The contents of this Addendum alter and amend the drawings and specifications and take precedence over the related items therein. Bidders shall include the cost of all items in their Bids.

LOWER POTTS GROVE TWP
LOWER POTTS GROVE MUNICIPAL
BUILDING & POLICE STATION
1963 E HIGH ST. POTTSTOWN, PA. 19464

CONSTRUCTION DOCUMENTS REVISION HISTORY		
ID	DESCRIPTION	DATE
B00	ISSUED FOR BID/PERMIT	9/3/2024
B01	ADDENDUM 3 REVISIONS	9/20/2024

S101

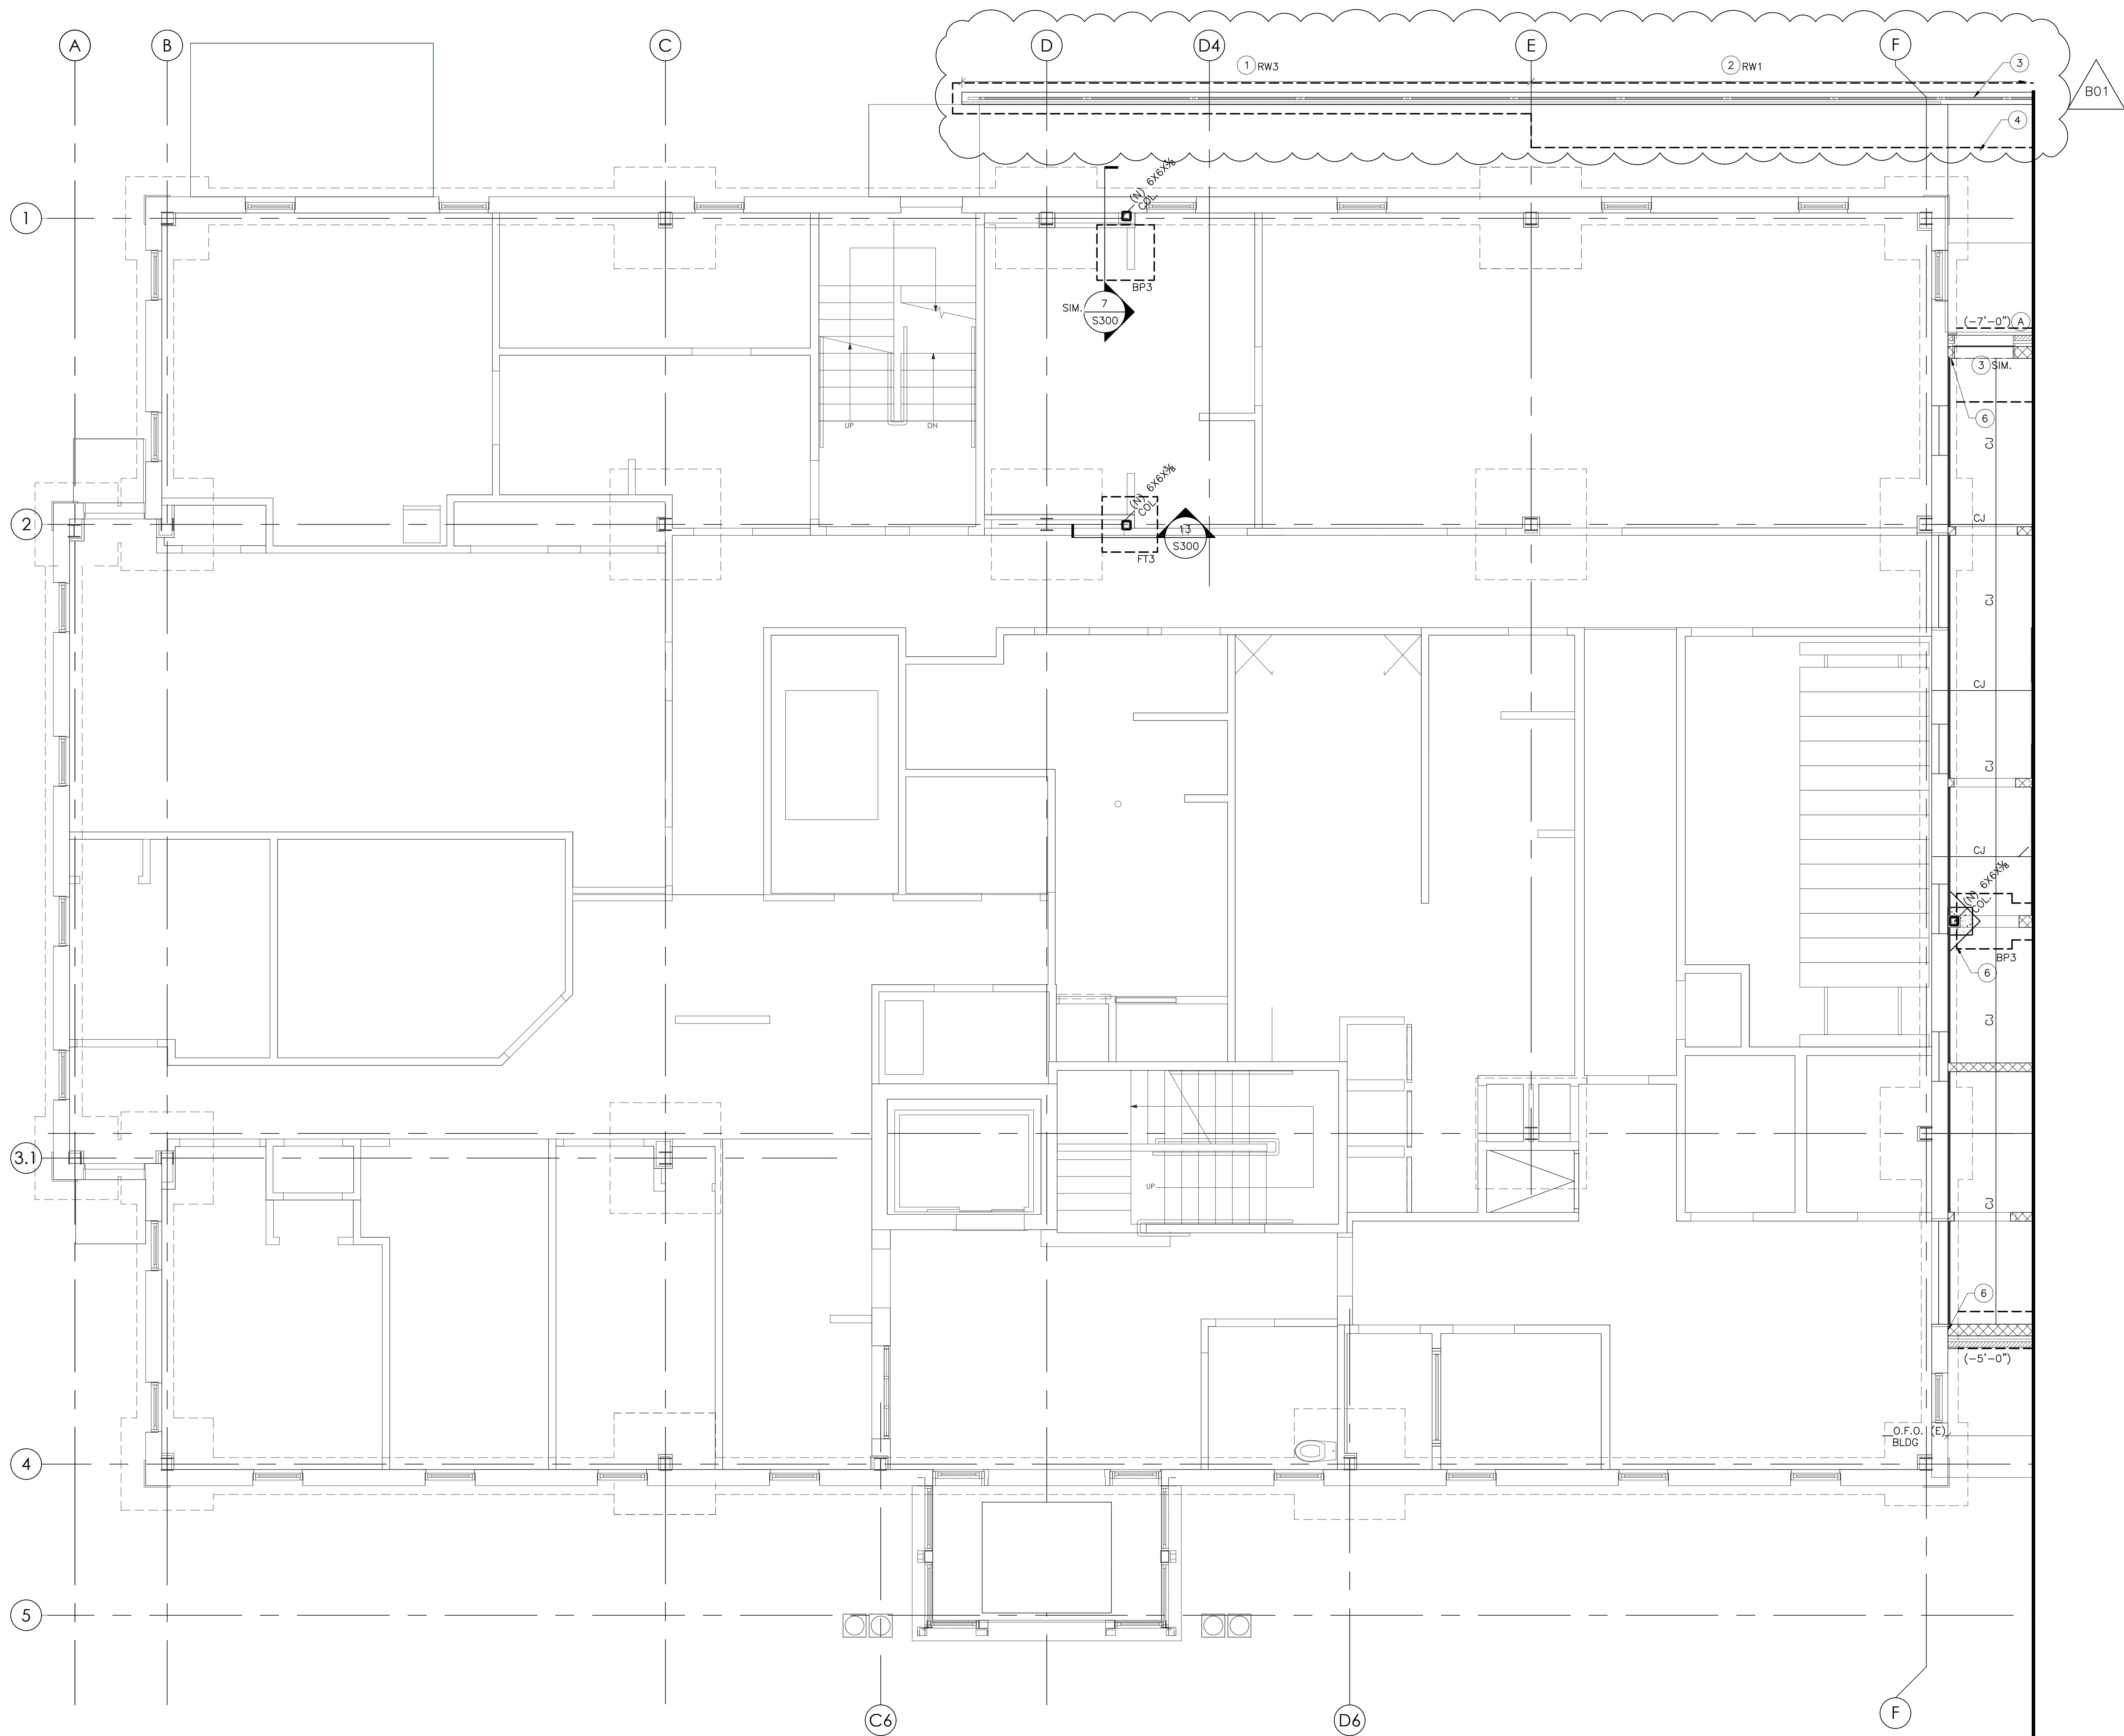
- A-702:** Soffits added at structural bracing.
- A-703:** Soffits added at structural bracing. Meeting room ceilings modified.
- S-101:** Retaining wall and footing information added.
- S-102:** Retaining wall and footing information added.
Header at Evidence Lockers and detail marker added.
- S-301:** Bracing details 9 & 10 clarified.
- S-302:** Retaining wall and footing details added.
- E-4:** Exterior wall pack lighting revised.
- E-5:** Light fixture designation at stair 1 corrected from 'DE' to 'LE.'
- E-7:** General notes 6 and 7 revised.
- E-12:** Lighting schedule corrected for fixture 'AF.'

11. PROVIDE WBx18 STL HEADER & PLATE, SEE DETAIL 5/S301.
12. (N) RAMP SUPPORT/RETAINING WALL, SEE DET 4/S302. STEP B.O. FOOTING AS REQ'D, SEE DET. 3/S300.

13. (N) RAMP SUPPORT/RETAINING WALL, SEE DET 3/S302. STEP B.O. FOOTING AS REQ'D, SEE DET. 3/S300.
14. (N) RAILING, SEE ARCH'L DWGS.
15. (N) CONC. SIDEWALK/RAMP, SEE ARCH'L DWGS.
